CITY OF ALBUQUERQUE

May 24, 2017

**RE: Oakland Ridge Subdivision
Grading Plan and Drainage Report
Stamp Date: 5/19/17
Hydrology File: C18D085**

Based upon the information provided in your submittal received 5/19/2017, the Grading Plan and Drainage Report is **not** approved for Preliminary Plat action by the DRB. The following comments need to be addressed for approval of the above referenced project:

FIGURE 4
OAKLAND RIDGE SUBDIVISION
SUB-BASIN BOUNDARY EXHIBIT

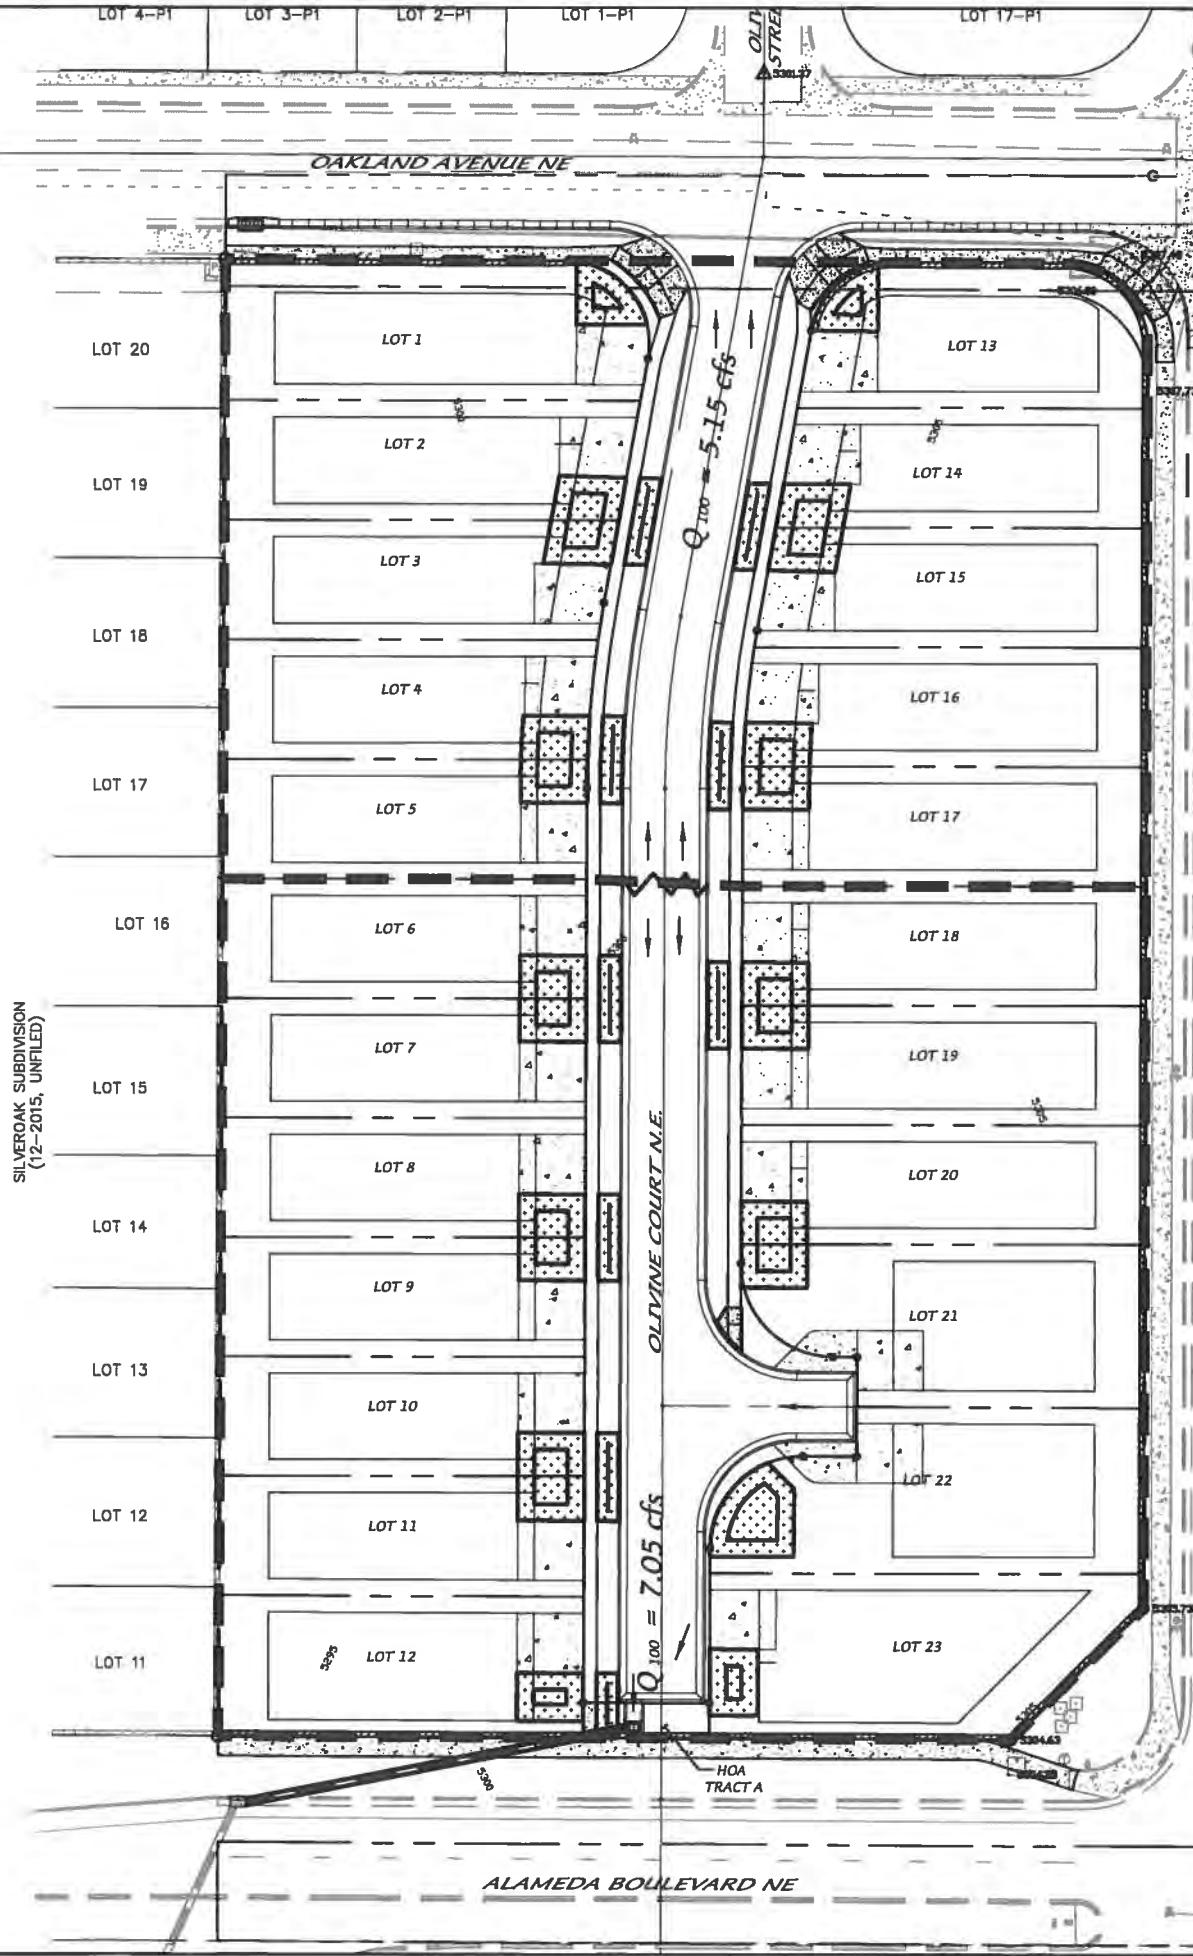
5. Please update Figure 4 as outlined above. Also please state the acreage of the North basin and the South basin.

SECTION A - A
TYPICAL DEPRESSED AREA
ON-SITE BETWEEN SIDEWALK & BACK OF CURB

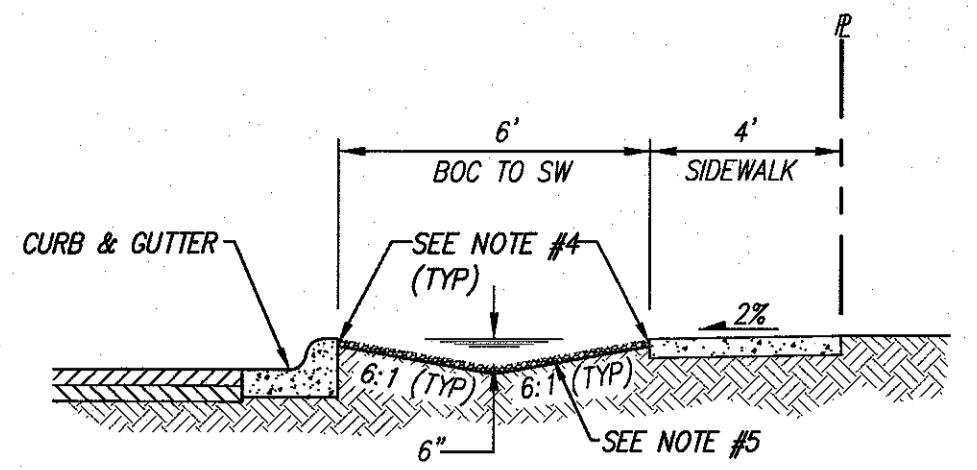
1. Please provide the street slopes.
2. The retaining wall along the East property line appears to have a constructability problem with undermining the existing sidewalk. Please provide a cross section.
3. Please add the site floodplain information.
4. On the Typical Depressed Area Detail, Notes #4 & 5 are missing. Please correct the Detail.

TYPICAL LOT GRADING SCHEME

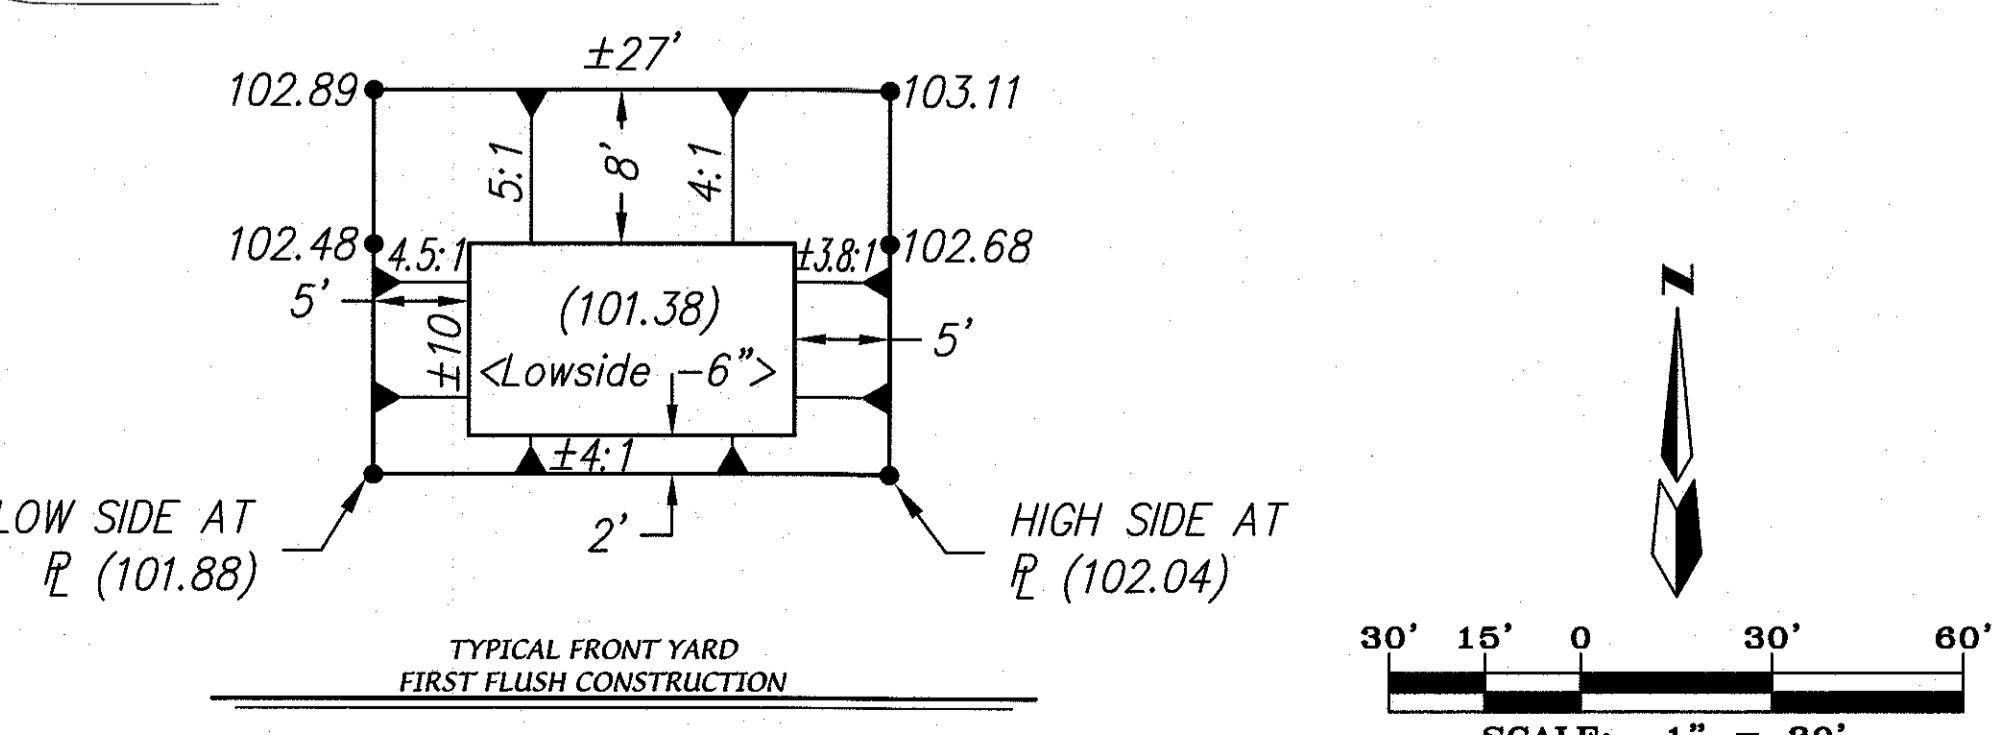
6. Please clarify the Typical Lot Grading Scheme. It appears that the back lot drainage will just travel either to the north or south depending on the grading without being directed to the first flush ponds.
